Picker Arm Support Strut - FCO CA04999

☑ Trendsetter VLF Autoloader Picker

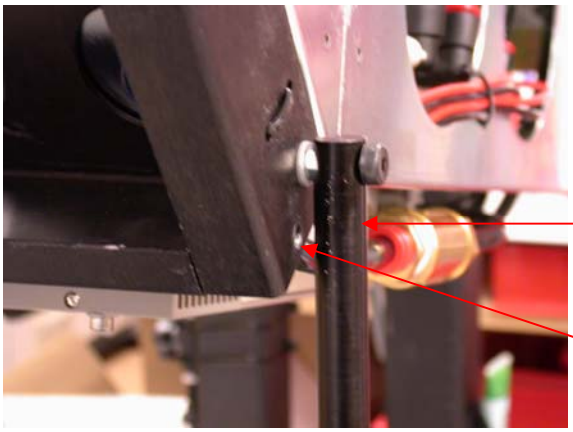
The current picker arm support strut does not lock and is easily dislodged. This creates a safety hazard when the picker arm is supported in the up position. See ECO CA04999 for details.

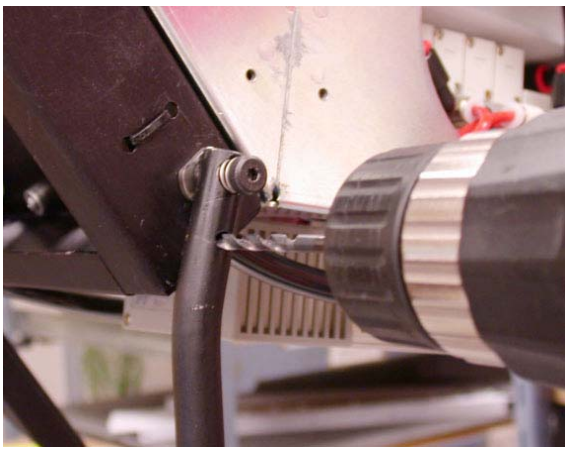
1. Remove the existing support strut shoulder bolt and remove the strut.

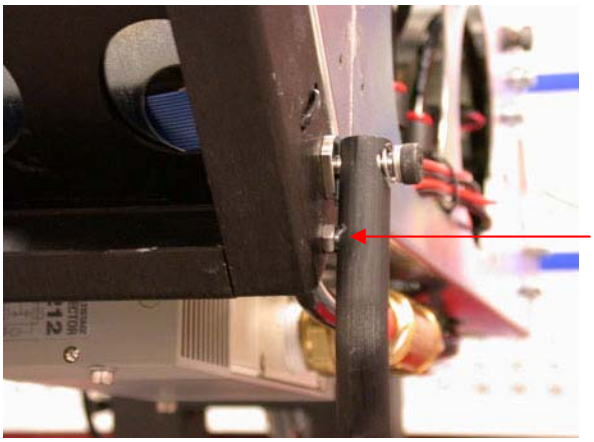
2. Install the locking pin (small bolt) in the existing hole in the picker arm. If this hole is not present, first install the new support strut and drill a 4 mm hole through the hole in the strut.

3. Install the new support strut. The locking pin should align with the hole in the support strut to lock the support strut in place when it is 90° to the surface below.
